Access Compliance Report Public Rights-of-Way (Curb Ramps)

Intersection ID: 53292 Main Street: PROSPERITY RIDGE RD Cross Street: ROBERT_HELMS_RD Location: W ADA ID: 53910BA2336D Ramp Type: Perp Initial Pass/Fail: Fail **Overall Compliance: No Severity Score:** 12.5

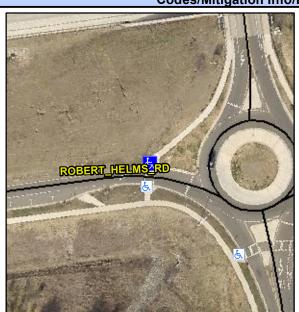
Field Measurements/Component Compliance						
Compliance Description		Data	Compliance		Description	Data
N/A	Ramp Length (in)	91.0	Yes	Ramp	Slope (%)	7.1
Yes	Ramp Width (in)	48.0	No	Ramp	XSlope (%)	5.′
N/A	Flare Type LT	N/A	N/A	Flare	Type RT	N/A
N/A	Flare Slope LT (%)	N/A	N/A	Flare	Slope RT (%)	N/A
N/A	Flare Traversable LT?	N/A	N/A	Flare	Traversable RT?	N/A
N/A	Landing Length (in)	N/A	N/A	DWS	Provided?	N/A
N/A	Landing Width (in)	N/A	N/A	DWS	Contrast?	N/A
N/A	Landing Slope (%)	N/A	N/A	DWS	Length (in)	N/A
N/A	Landing X Slope (%)	N/A	N/A	DWS	Full Width?	N/A
N/A	Landing Curb? (Y/N)	N/A	N/A	DWS	Offset (in)	N/A
N/A	Shared Landing?	N/A				
N/A	Gutter Ponding?	N/A	N/A	Gutte	r Slope (%)	N/A
N/A	Gutter Lip Ht (in)	N/A	N/A	Gutte	r X Slope (%)	N/A
N/A	Painted X Walk1?	Yes	N/A	Paint	ed X Walk2?	N/A
	X Walk 1 Direction	To S		X Wa	lk 2 Direction	N/A
N/A	X Walk 1 Width (in)	103.0	N/A	X Wa	lk 2 Width (in)	N/A
	X Walk 1 Slope (%)	1.8		X Wa	lk 2 Slope (%)	N/A

ROBERT HELMS RD Street 1 Name YieldSign Stop Condition-Street 2 Street 2 Name N/A Stop Condition-Street 1 N/A Possible Solutions: Remove & Replace Entire Ramp. Surveyor Notes: N/A PROW/ADA: R304.5.3
